FANNY STREET BIKE TRACK UPGRADE /

DRAFT DESIGN PUBLIC
CONSULTATION REPORT.

CITY OF MOONEE VALLEY.
APRIL 2022

DRAFT DESIGN CONCEPT PLAN /

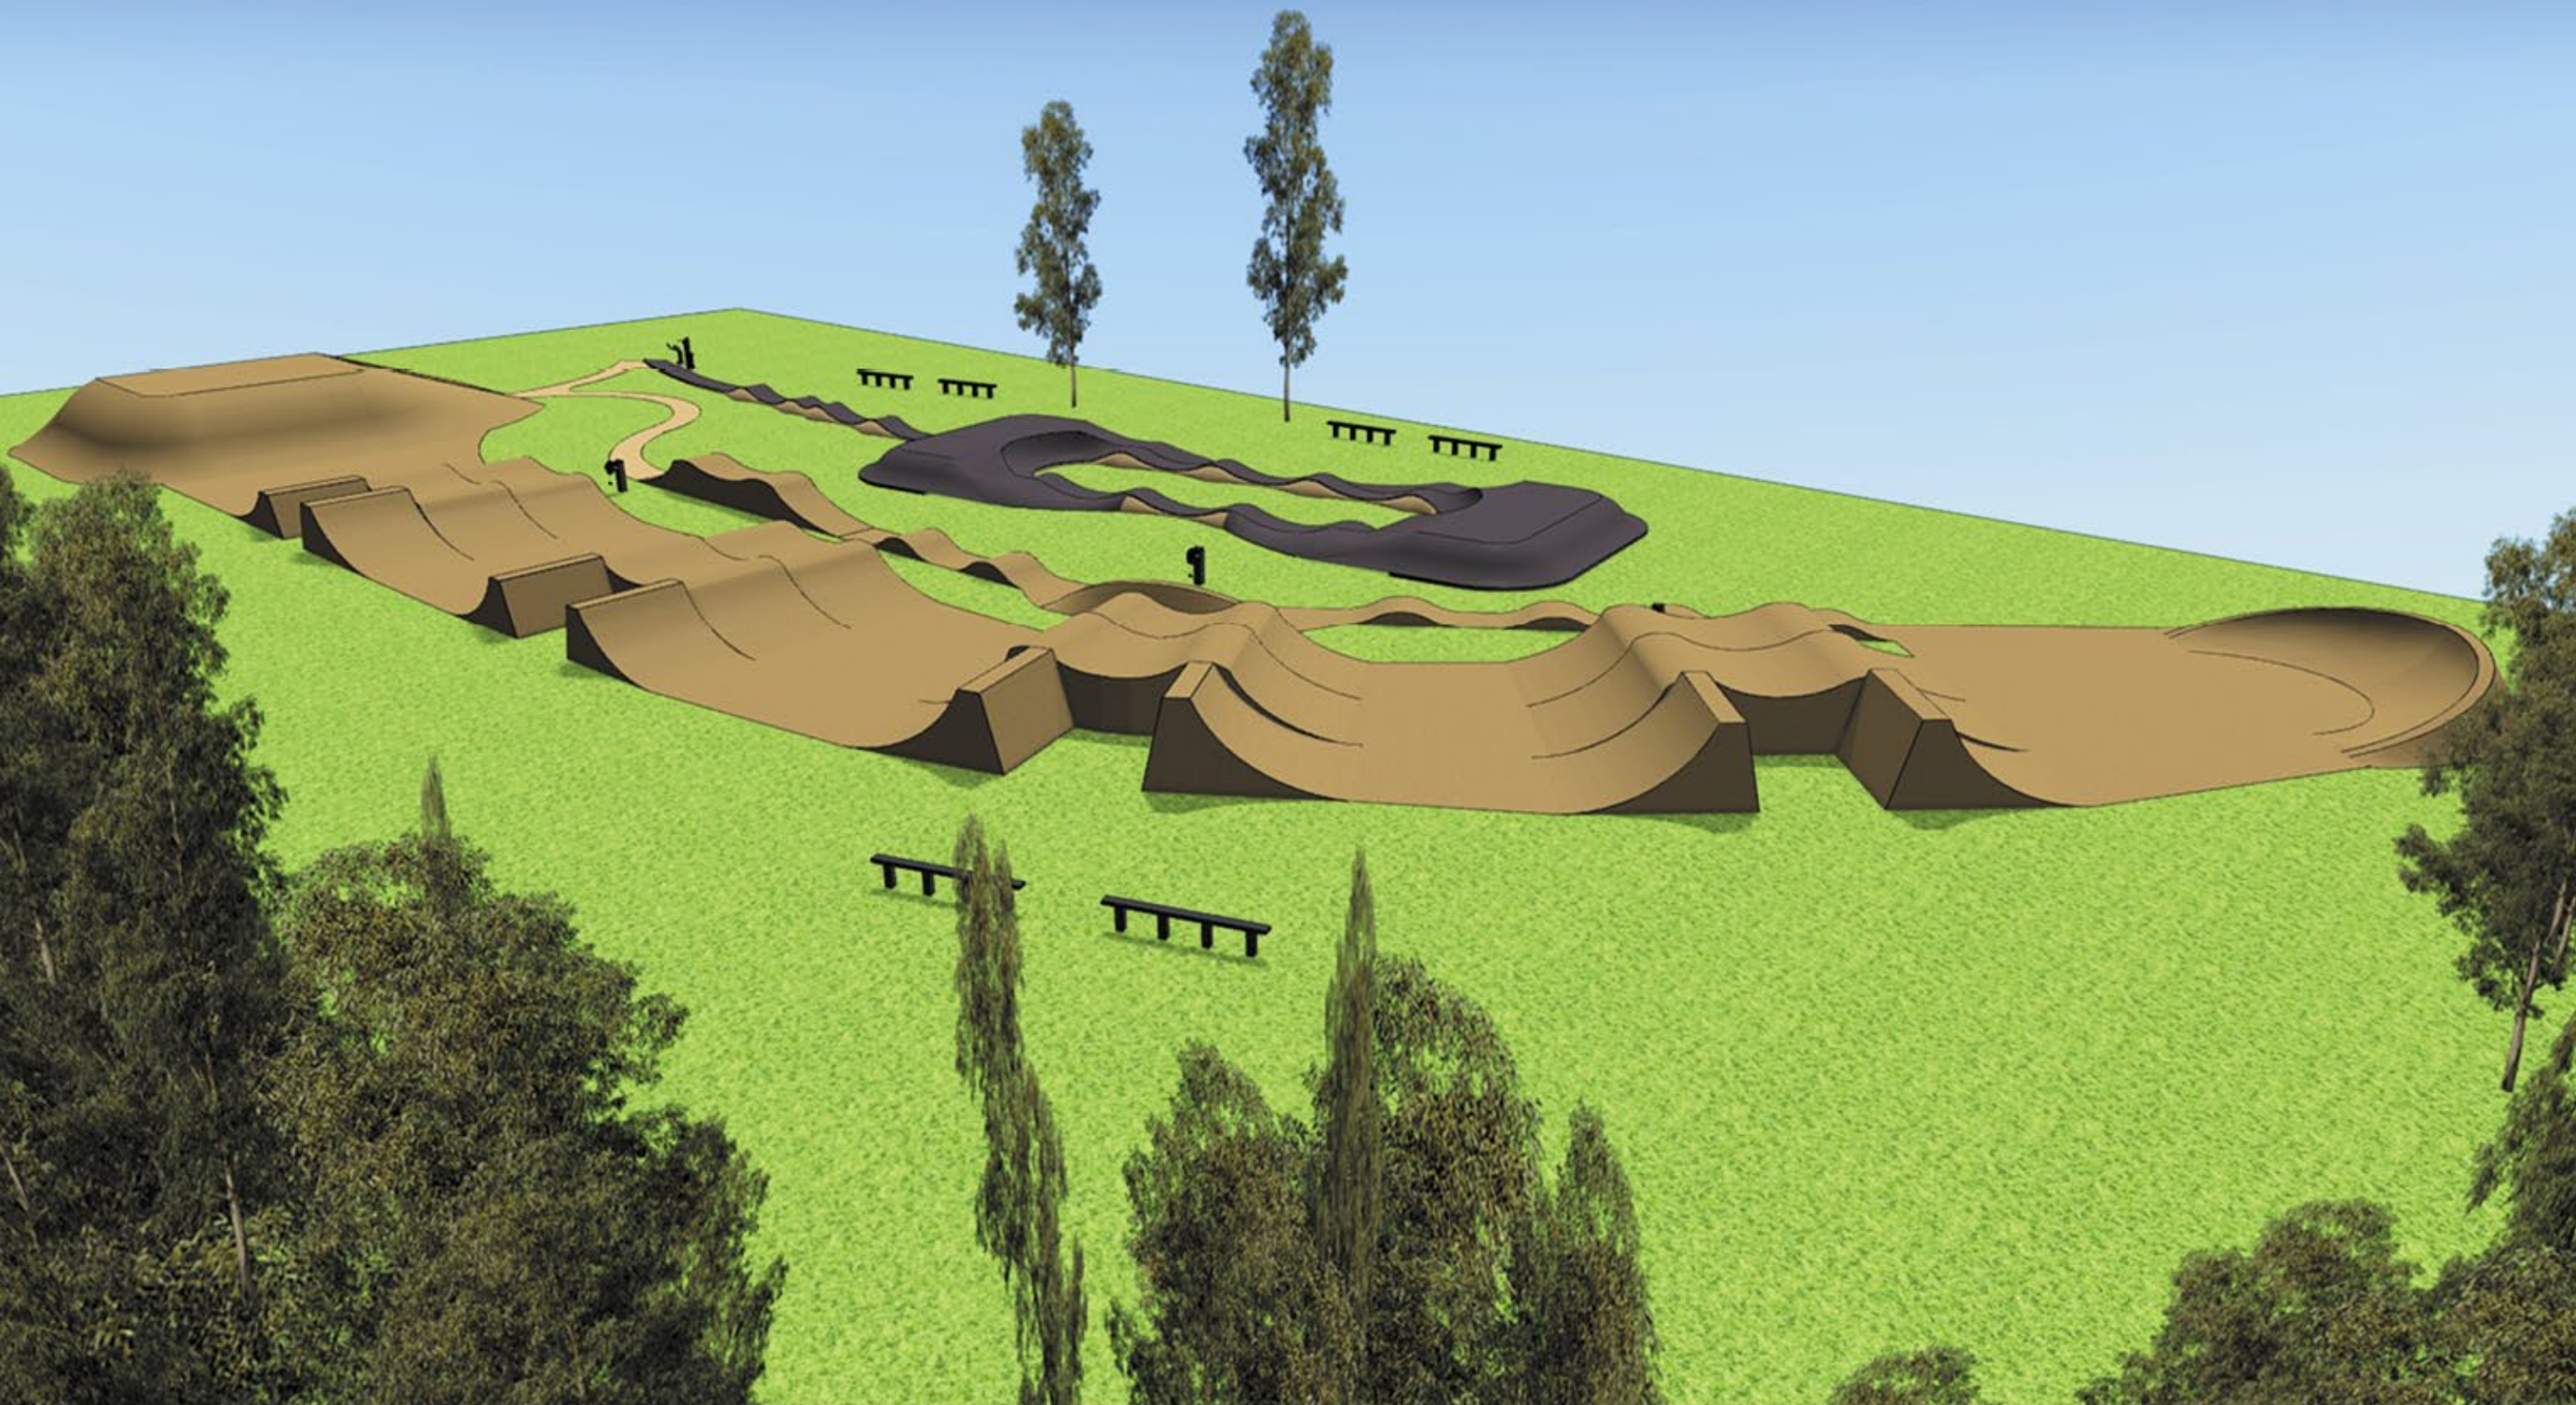
There is no toilet at the Reserve. Please add a toilet. Also the track is frequented by young children, the proposed track appears too dangerous and will cause injuries with section 4 of the track if young kids accidentally rode off the ledges.	March 16, 2022 7:12 pm	↗
The design looks very exciting (to a non-expert in these things!) and a big improvement on the current track. However with such an upgrade it would really need to come with an overall upgrade in facilities at the park - very importantly toilets! And also some shade and seating options and good consideration to issues like rubbish disposal. As a local who frequently visits the park it can get really busy on nice weekend days both with locals and people stopping off from the bike path, and the facilities are already lacking - no toilets, bins often overflowing, rubbish and litter issues (often including broken glass), the two picnic tables are wobbly and there's not enough of them, and there's not much shade. These issues would only become worse if the park became more of an attraction with the new bike track. As a point of comparison I invite council or those doing the upgrade to consider the recently upgraded Hansen Reserve in Footscray which has a great bike and scooter area for kids, sheltered bbq and picnic areas, a new playground, and of course toilets.	March 16, 2022 7:51 pm	↗

A LOT OF PEDESTRIANS/CYCLISTS/DOG WALKERS CUT FROM EVANS ST, DIRECTLY ACROSS THE MIDDLE OF THE PARK TO SALISBURY ST, WHICH IS WHERE THE PROPOSED BIKE TRACK WILL BE. THIS PRESENTS A DANGER IF PEOPLE CONTINUE TO DO SO, THROUGH THE ^{NEW} BIKE TRAFFIC.

CONSIDER A NEW PATH AROUND THE BIKE TRACK. NOTE THAT THE CURRENT PATH, ALONG THE FENCELINE AT SOUTH BOUNDARY OF FANNY RESERVE IS UNAPPEALING/FEELS THREATENING BECAUSE OF THE HEAVY VEGETATION - CONSIDER THINNING THIS OUT & OPENING UP SIGHTLINES TO/FROM THE PATH.

Red 1 Bench seating should be removed as residents from Evans Street ride down the hill to the park, having the benches there would pose a dangerous obstacle.
